UNITED STATES PATENT AND TRADEMARK OFFICE

| APPLICATION NO. | FILING DATE | FIRST NAMED INVENTOR | ATTORNEY DOCKET NO. | CONFIRMATION NO. |
|--|-------------|------------------------|---------------------|------------------|
| 10/789,637 | 02/27/2004 | Brian S. Schieck | NVID-P001125 | 7655 |

Office Action Summary

DETAILED ACTION

FIG. 1

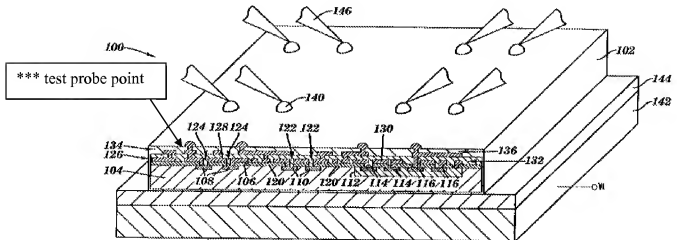
Re claim 1, Motika et al. ("Motika") discloses in FIG. 1 a semiconductor die 102 comprising: a conductive test signal bump 140 for transmitting test signals off of said semiconductor die 102; a test signal redistribution layer trace 126 for communicating said test signals to said conductive test signal bump 140, wherein said test signal redistribution layer trace 126 is included in a redistribution layer (126/132/134) and said test signal redistribution trace 126 is disposed such that multiple test signals are accessible at varying degrees of electronic component granularity within said die 102 and along said test signal redistribution layer trace 126, said test signal redistribution layer trace 126 communicatively coupled to said conductive

test signal bump 140; and a test probe 136 point for accessing said test signals in said semiconductor die 102 and for electrical coupling to said redistribution layer.

Re claims 3-5, the claims recite the following product-by-process limitations: "accessible by drilling" (claim 3); "a focused ion beam (FIB) pad accessible by focused ion beam drilling and conductive material backfill" (claim 4); and "conductive material backfill" (claim 5). However, these limitations have not been given patentable weight because product-by-process claims are not limited to the manipulations of the recited steps, only the structure implied by the steps. "[E]ven though product-by-process claims are limited by and defined by the process, determination of patentability is based on the product itself. The patentability of a product does not depend on its method of production. If the product in the product-by-process claim is the same as or obvious from a product of the prior art, the claim is unpatentable even though the prior product was made by a different process." In re Thorpe, 777 F.2d 695, 698, 227 USPQ 964, 966 (Fed. Cir. 1985). Thus, as shown in FIG. 1 of Motika above, the test probe point 136

comprises a bonding pad 136 which is coupled to said test signal redistribution layer (126/132/134), wherein the bonding pad 136 is communicatively coupled to said test signal redistribution layer trace 126 by a conductive material backfill.

Applicant persistently argues that Motika does not teach the semiconductor die comprising a test probe point for accessing the test signals in the semiconductor die. In response, the Examiner respectfully disagrees because Motika clearly shows in FIG. 1 a test probe 136 point for accessing said test signals in said semiconductor die 102 and for electrical coupling to said redistribution layer (126/132/134).

Applicant persistently argues that Motika does not teach “the test signal redistribution trace is disposed such that multiple test signals are accessible at varying degrees of electronic component granularity within the die and along the test signal redistribution trace”. In response, the Examiner respectfully disagrees because Motika clearly shows in FIG. 1 the test signal redistribution trace 126 is disposed such that multiple test signals are accessible at “varying degrees of electronic component granularity” within the die 102 and along the test signal redistribution trace 126. The “varying degrees of electronic component granularity”, in this case, can be interpreted as various number of electronic components on the substrate 104 within the die 102. Thus, the Examiner respectfully submits that no matter where a test point is moved

along the redistribution trace 126, it is limited to various number of electronic components within the die 102.
